**PUBLIC WORKS**  
Engineering

1. Approve Modification to Standard Detail 553 - 4" - 10" Double Check Detector and Vault Assembly.

4"-10" DOUBLE DETECTOR CHECK  
AND VAULT ASSEMBLY

STD. 553

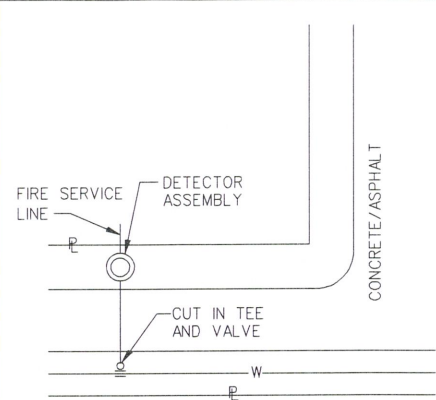
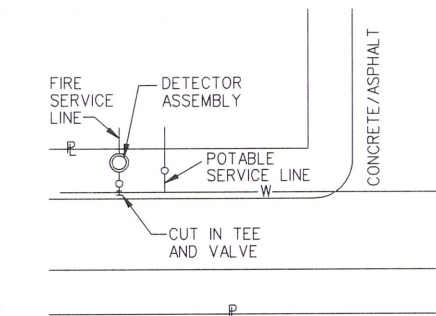
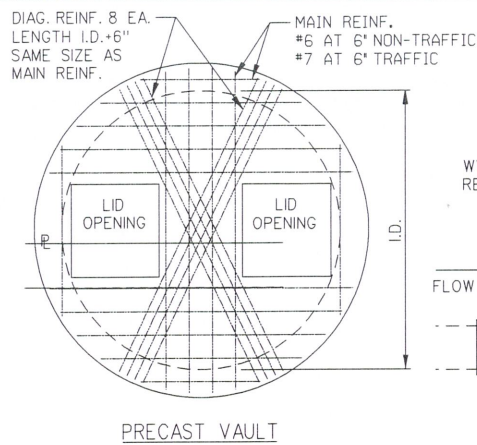
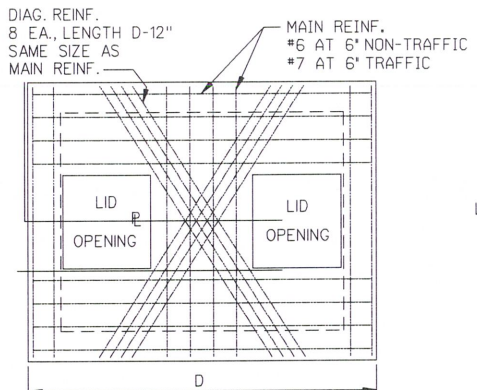
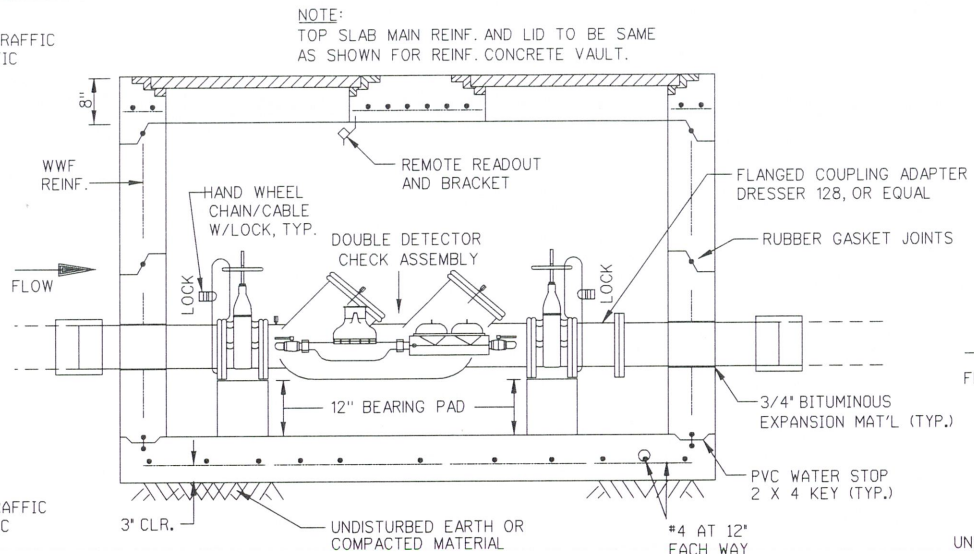
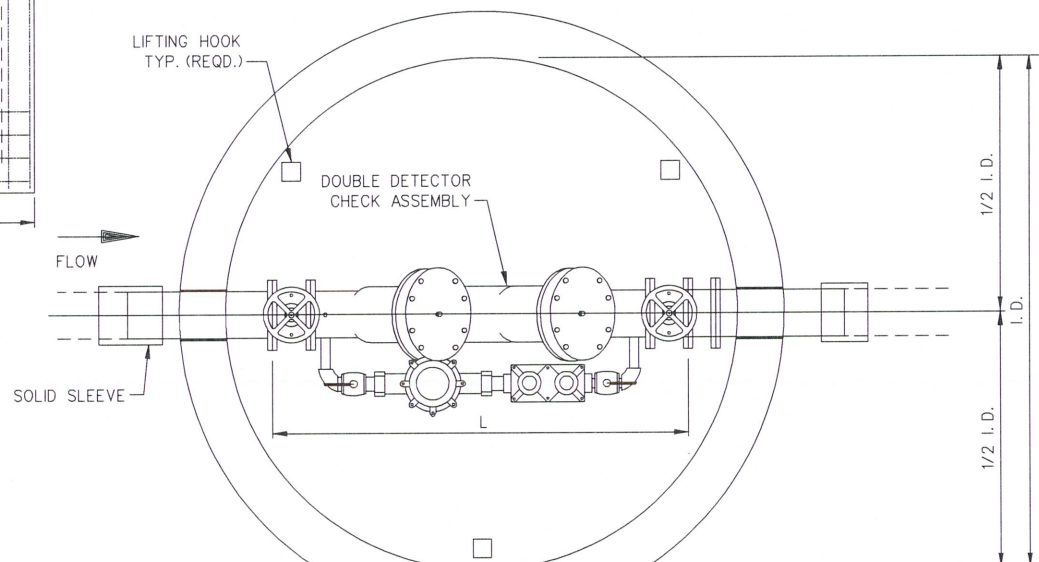
Summary of change: Tapping Sleeve and Valve has been deleted.  
Allowance through technical variance only.  
Added a prohibition on combined use through  
one meter.

- DRAWINGS NOT TO SCALE.
- TAPPING SLEEVE AND VALVE CONNECTIONS ARE APPROVED ON AN AS NEEDED BASIS THROUGH A TECHNICAL VARIANCE.
- A COMBINATION OF FIRE, DOMESTIC, AND LANDSCAPE METERS IS PROHIBITED EACH DEMAND REQUIRES A SEPARATE SERVICE CONNECTION.
